March 1, 1999

**Re: Conditional Approval of Supplemental Source Control
Containment/Recovery Measures East Street Area 2,
General Electric Company, Pittsfield, Massachusetts
DEP Site No. 1-0146, USEPA Area 4**

FIGURE
1

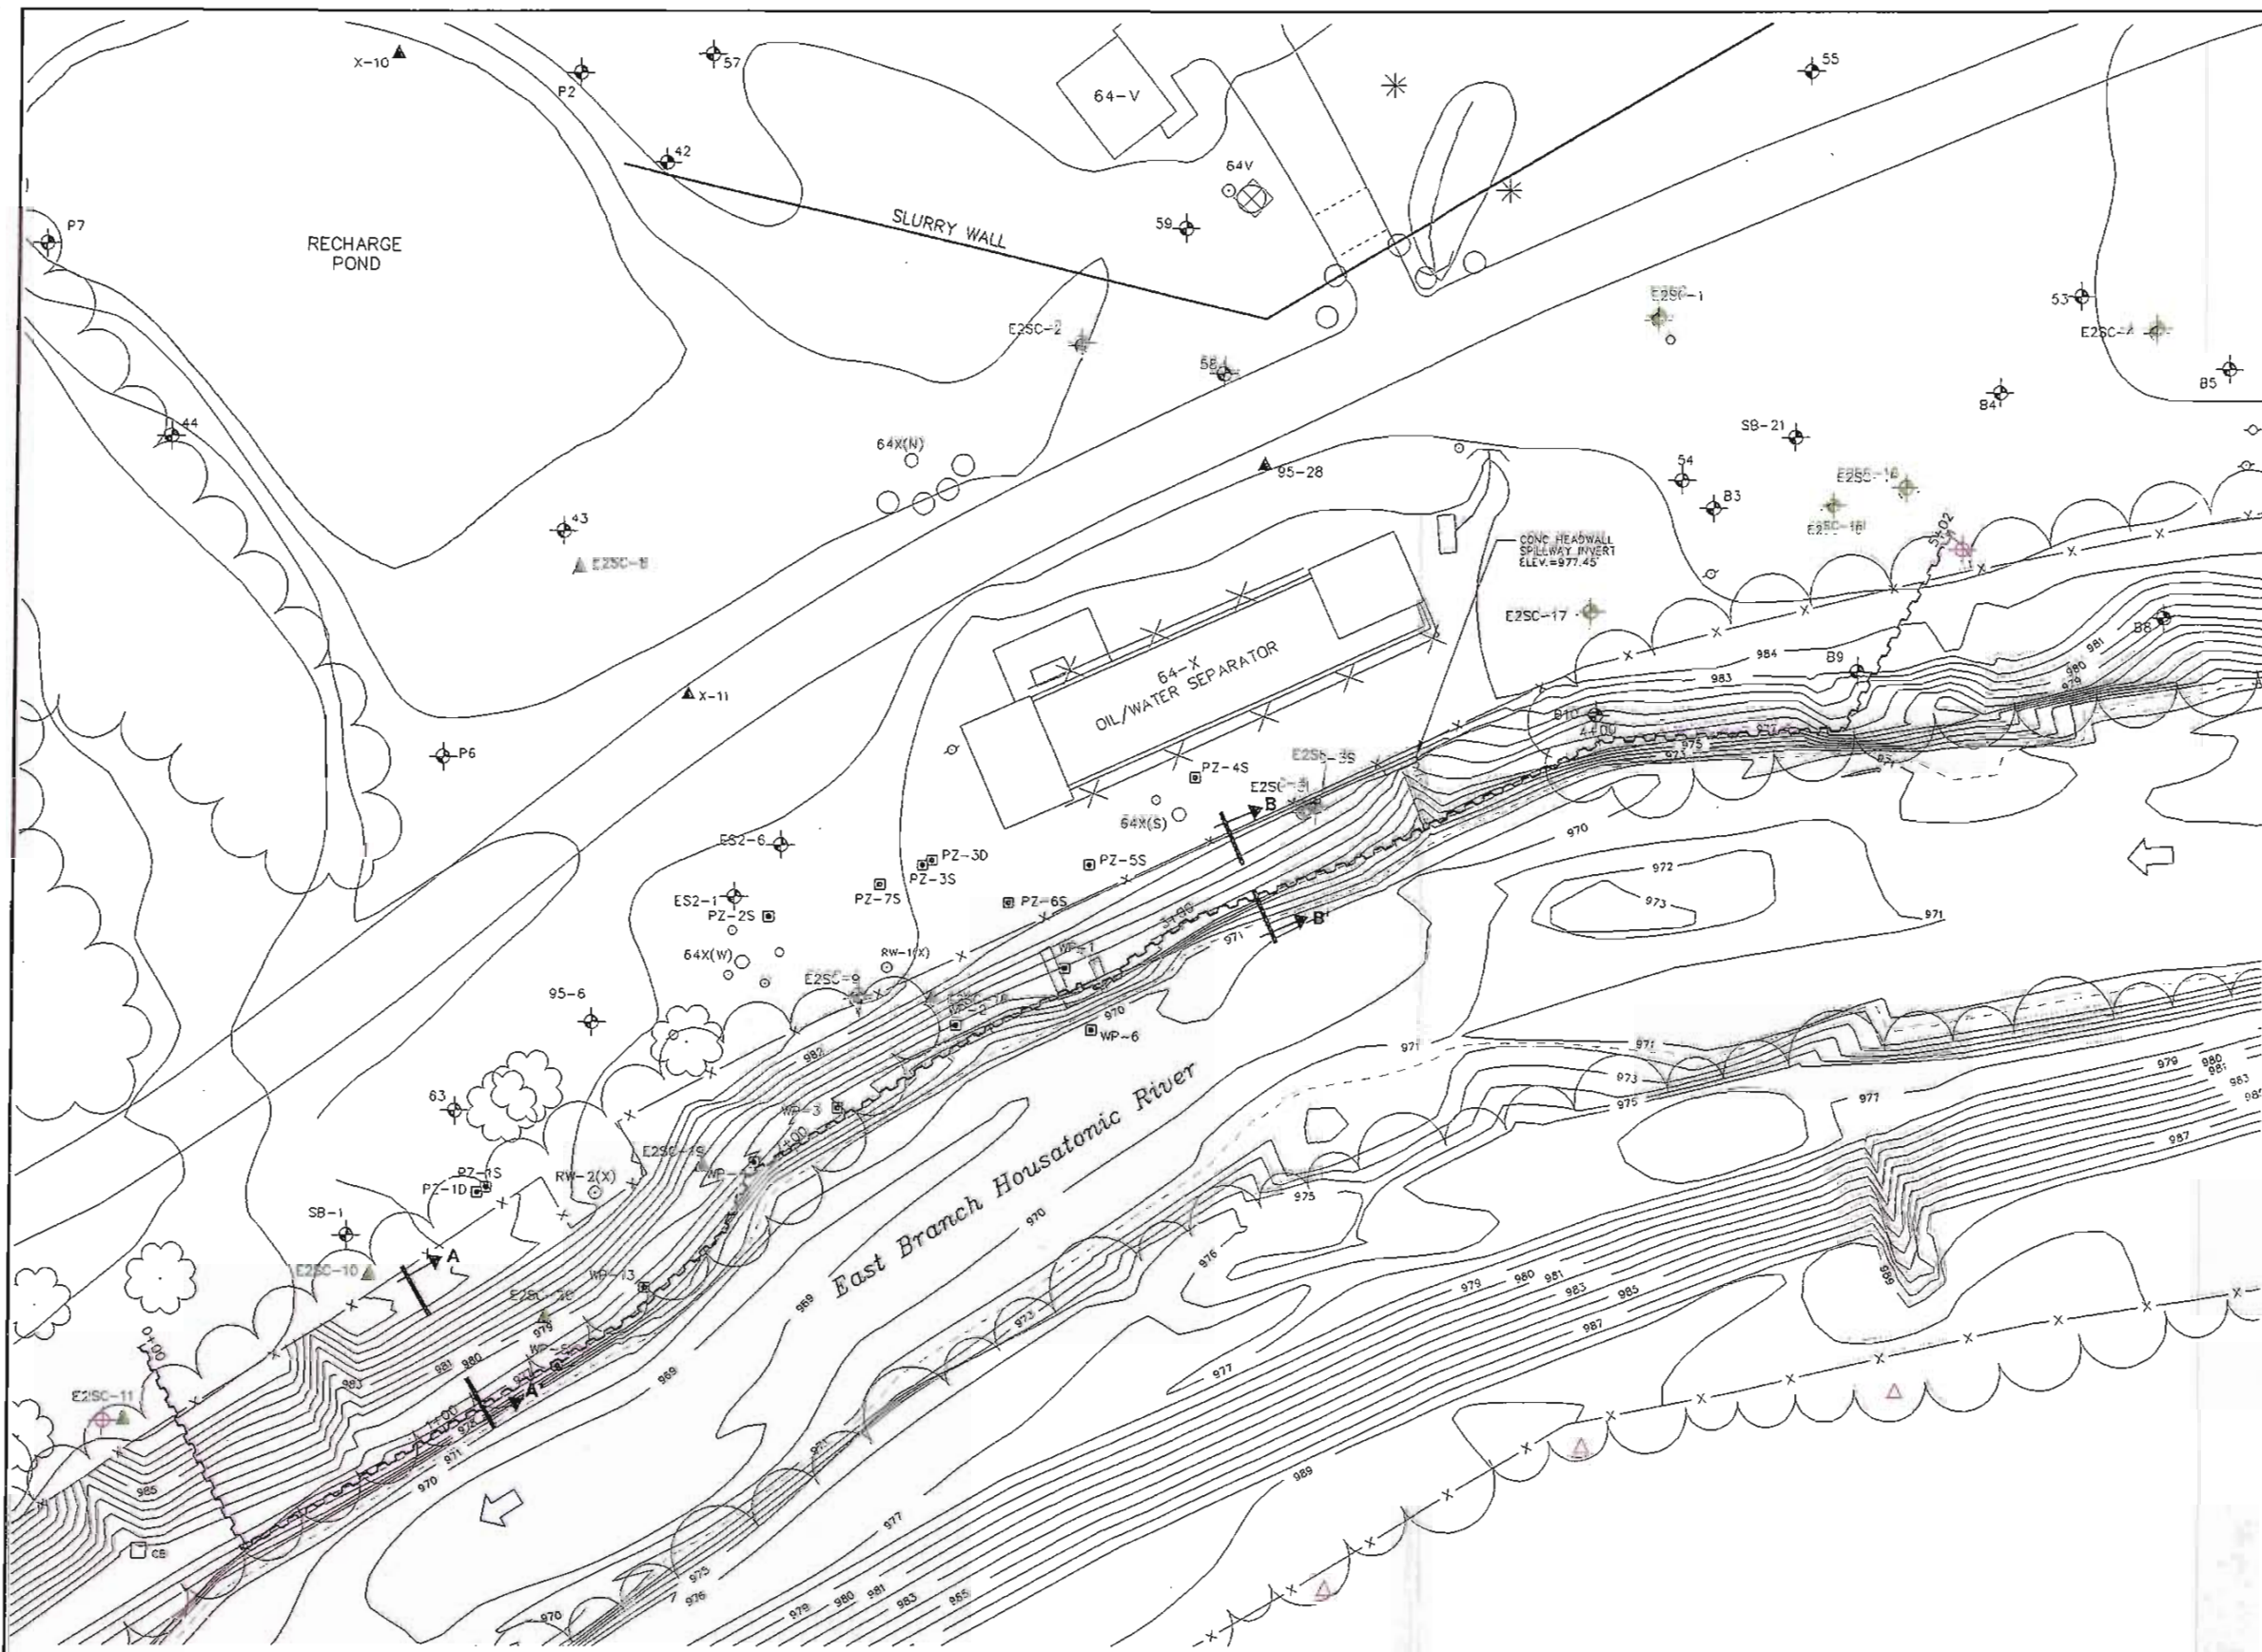
1. Install two monitoring wells at the east and west ends of the proposed containment barrier, respectively, to detect any potential LNAPL migration around the ends of the barrier (refer to Figure 1);

As part of its February 11, 1999 conditional approval letter, the USEPA presented several comments concerning the proposed configuration of the sheetpile wall in the vicinity of the west headwall as presented on Sheet 5 of Appendix D of the Supplemental Source Control Proposal. In general, these comments relate to the integration of the sheetpile wall with the headwall without resulting in permanently exposed sheetpiles along this portion of the river.

Figure 1 depicts the proposed re-alignment of the sheetpile wall necessary to fulfill the criteria in Item 1 in the preceding paragraph. This re-alignment was generated by assuming that bank soil removal could extend horizontally to the edge of the river. Placement of a 1:1 slope will require a width of 5.0 feet between the sheetpiling and the river edge to avoid encroachment on the river channel. This guideline results in the sheetpiling re-alignment shown on Figure 1. Note that, in certain areas, the sheetpile top elevation 977 feet is now below existing grade (generally near upstream wing wall). Hence, the height of the sheetpile top in these areas will be adjusted to allow for the re-alignment on Figure 1.

In response, GE proposes to install three soil borings along the south bank of the Housatonic River at the locations shown on Figure 1. These borings will be installed and sampled in a manner consistent with the previous source control investigation borings installed at the East Street Area 2 site. These borings have been located in a potential "trough" area in the till surface as indicated by the geophysical data presented in the Source Control Report.

In response to these comments, the alignment of the sheetpile wall in the vicinity of the west headwall has been modified to address the USEPA's comments. The modified connection details are shown on Figure 1 and in Attachment 4. Specifically, the sheetpile wall alignment has been changed such that it will extend out flush with the front face of the west headwall, with the use of "L" sections on either side of the headwall. To accomplish this, longer sheets will be used in this area so that the driving hammer will not be obstructed by the existing headwall. The sheets will then be cut flush with the top of the headwall once they have been driven to the desired depth. A new concrete headwall will be constructed on the face of the sheetpile such that the sheetpile will not be exposed. Geotextile and riprap will be placed at the excavated toe of the bank slope as a measure of erosion protection until such time that final excavation and restoration activities are conducted as part of the ½-Mile Removal Action Work Plan activities.

FIGURE
3

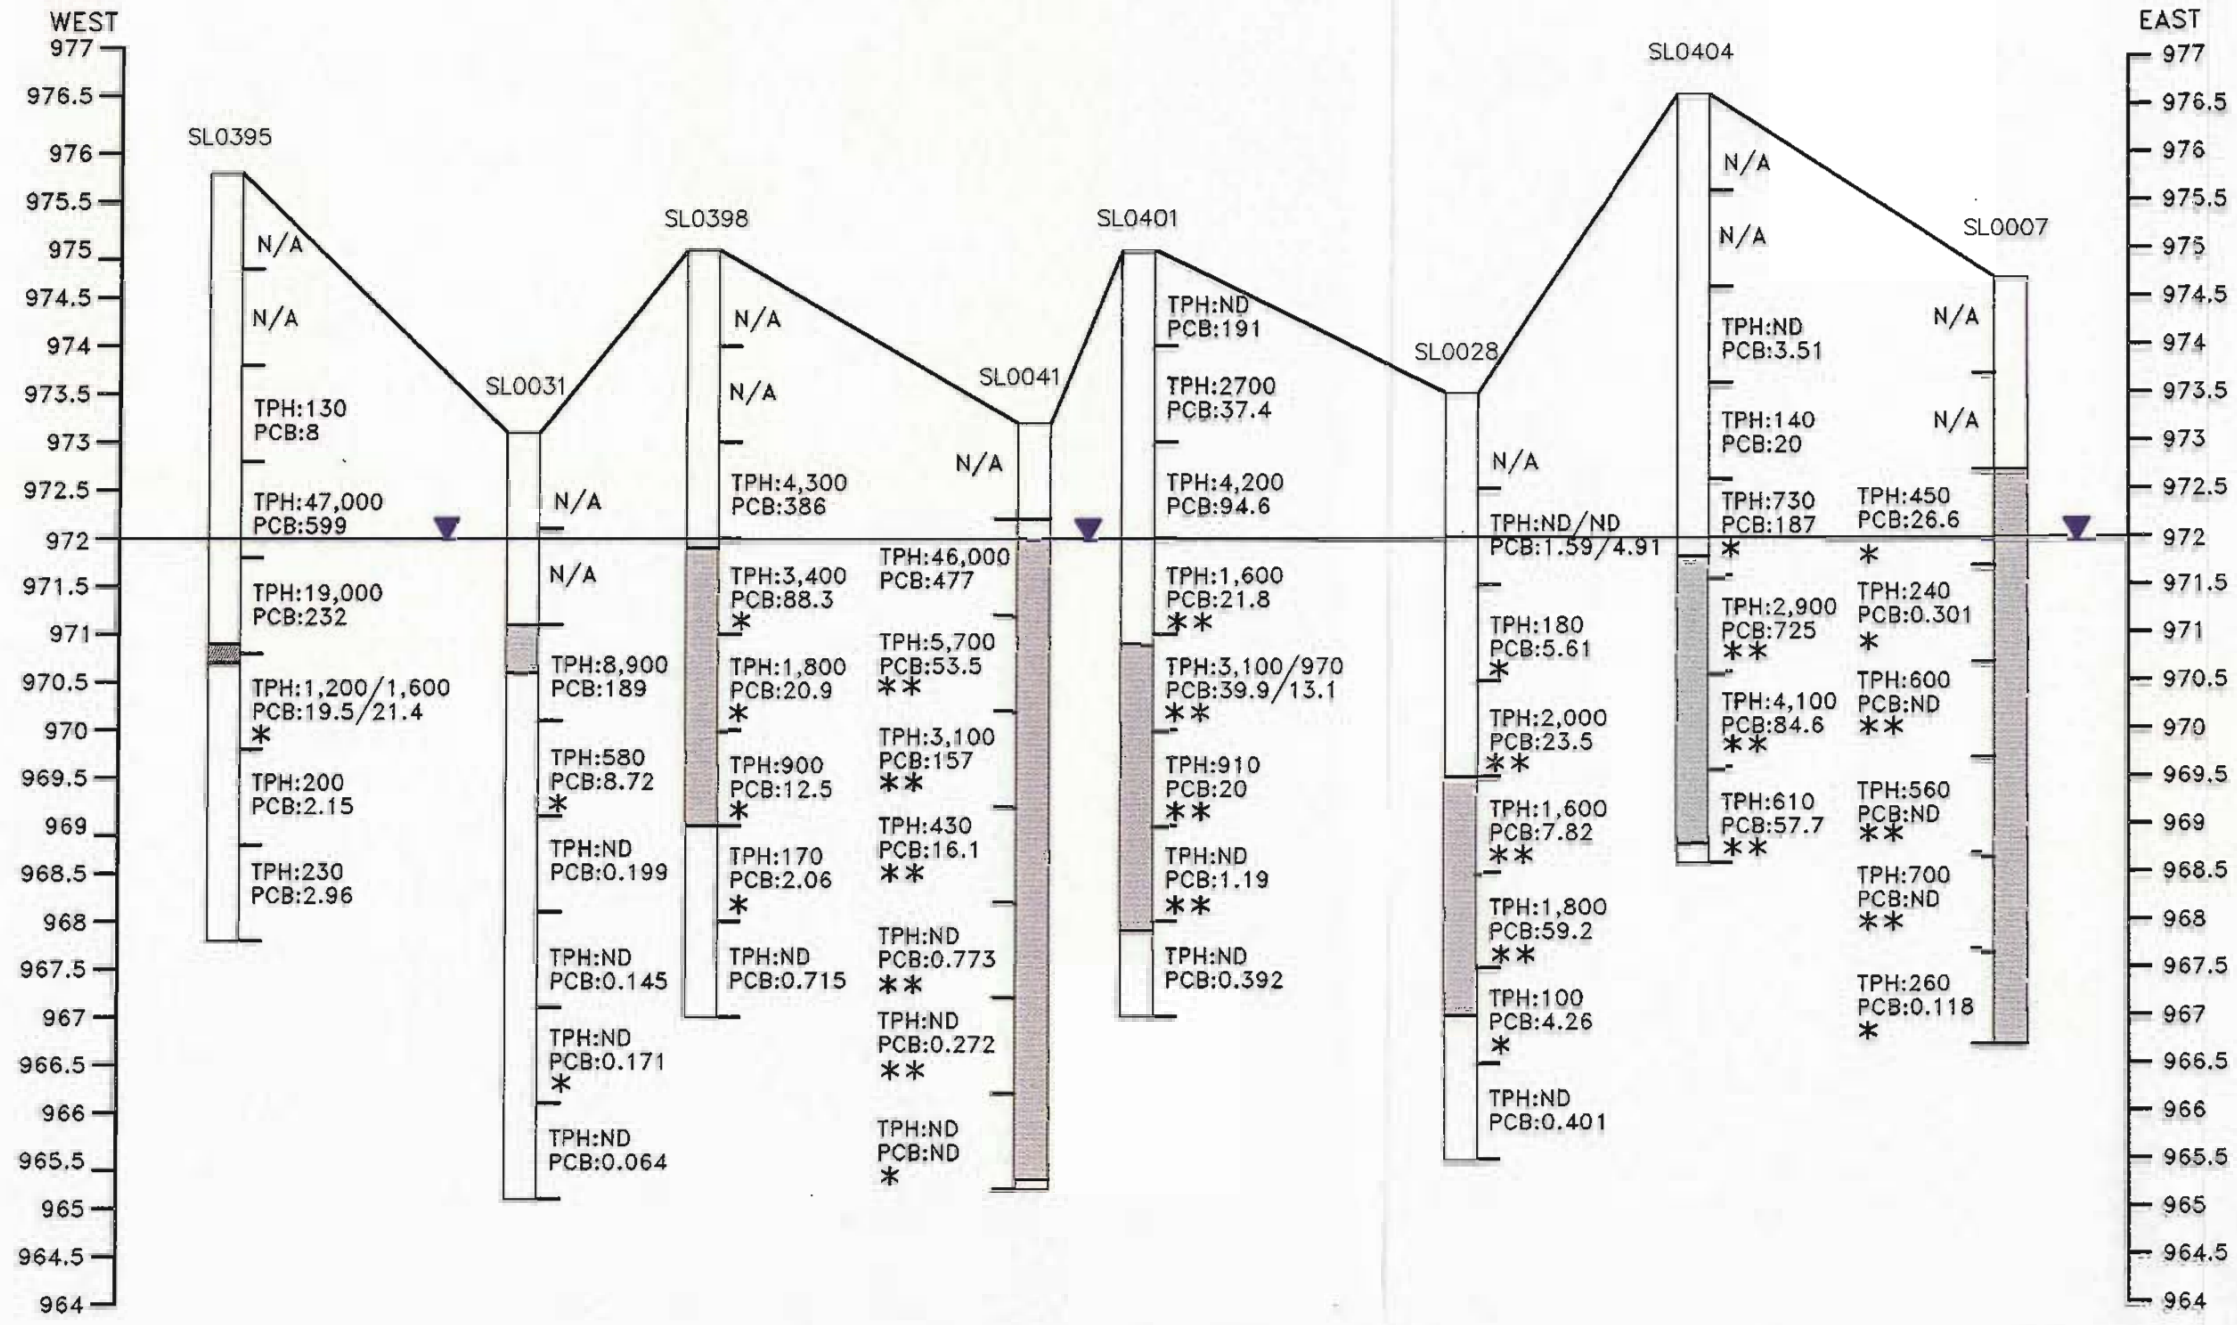
- 3) The containment barrier design calculations have been re-evaluated to consider the other USEPA comments, the recently collected bank soil/sediment data, removal depths proposed in the ½ -Mile Removal Action Work Plan, and changes in horizontal placement of the containment barrier to allow for a 1:1 slope as part of final restoration activities. The revised calculations are presented in Attachment 1. Figure 1 illustrates the revised layout of the proposed containment barrier, and a discussion of the 1:1 slope evaluation is presented in Section VI.

As a result of the re-evaluation of the design calculations, it has been determined that the previous design depth for the bottom of the containment barrier (i.e., 20 feet) should generally be extended 5 feet (for an overall depth of 25) to provide a reasonable degree of safety. Additionally, in a limited area adjacent to the proposed 2.5 foot removal area near sediment sample location SL0404, the sheetpile should extend 3 feet deeper (to a depth of 28 feet). The factor of safety for the permanent condition, i.e., after the sheeting is installed and the ½ -Mile Removal Action activities are completed, is greater than 2.0. For the temporary condition, i.e., when sediments/banksoils are excavated to maximum depths corresponding to elevations of 966.5 to 967.5 feet, the factor of safety is at least 1.25. Figure 4 illustrates a revised containment barrier profile.

FIGURE
5

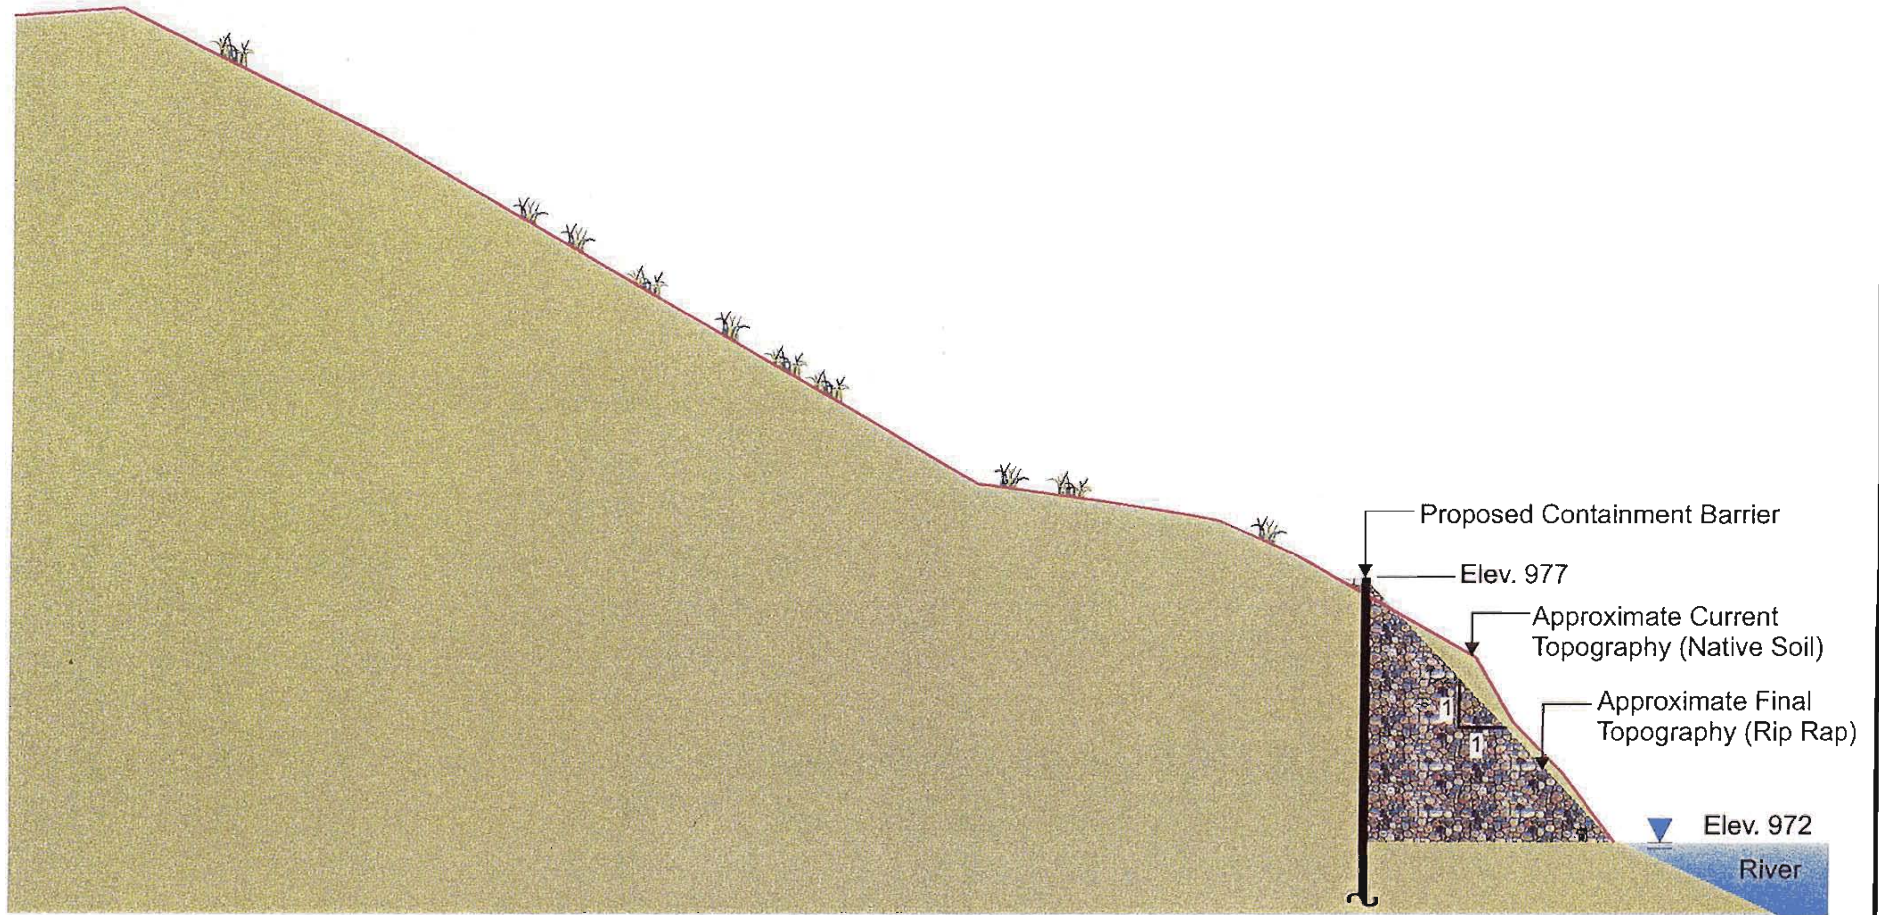
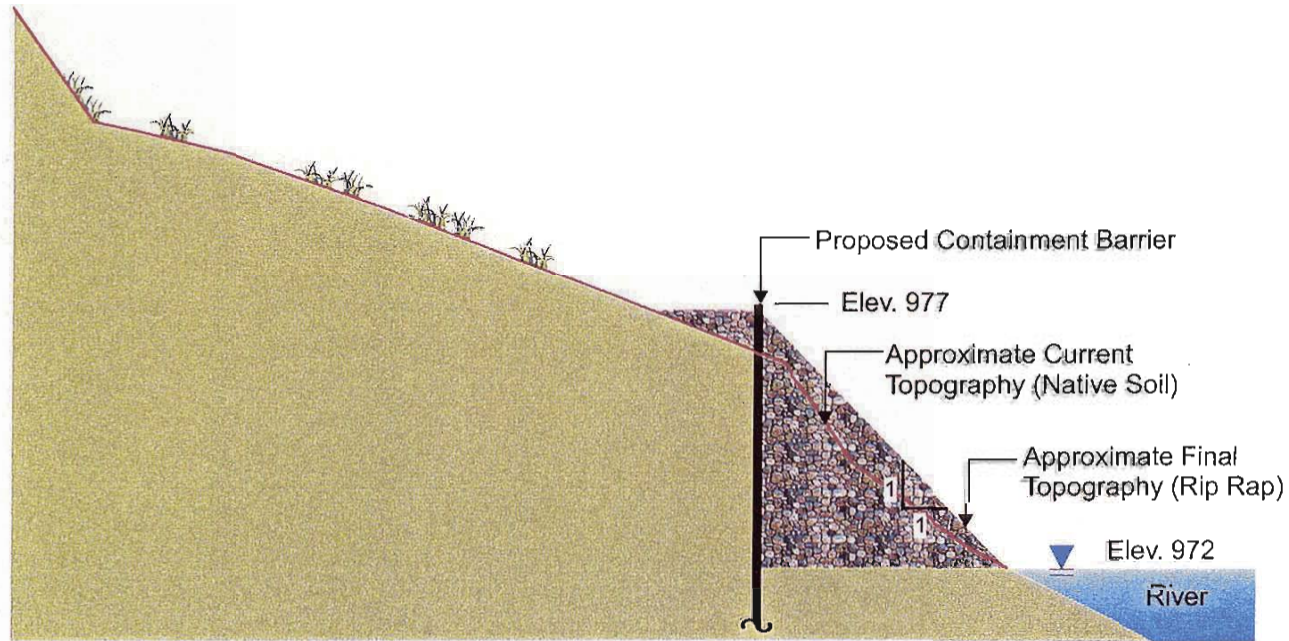
In addition to responding to the USEPA's above-listed comments relating to site restoration, and as mentioned in Section III above, GE's technical consultant, BBL, has evaluated restoration conditions associated with a 1:1 slope along the riverside of the proposed sheetpile wall. Specifically, the evaluation was conducted to ascertain: 1) the location of the sheetpile wall necessary to result in an approximate 1:1 slope between the top of the wall (i.e., elevation of 977 feet) and the edge of the Housatonic River (i.e., assumed at an average elevation of 972 feet); and 2) the potential change in flood storage volume resulting from the proposed activities, incorporating the re-alignment of the sheetpile to achieve a 1:1 slope.

Figures 5 and 6 present two illustrative cross sections of the proposed sheetpile and bank restoration. Figure 1 also depicts these cross section locations along the sheetpile. The cross sections represent approximate typical sections for calculating changes of flood storage capacity (discussed below) due to the removal of bank soil associated with sheetpile installation and restoration of the lower portion of the bank with rip-rap at a 1:1 slope.

The volume of the existing soil located between the sheetpile wall and the river is estimated at 116 cy. The volume of the riprap backfill is 205 cy. The resultant change in flood storage capacity is a loss of approximately 89 cy.
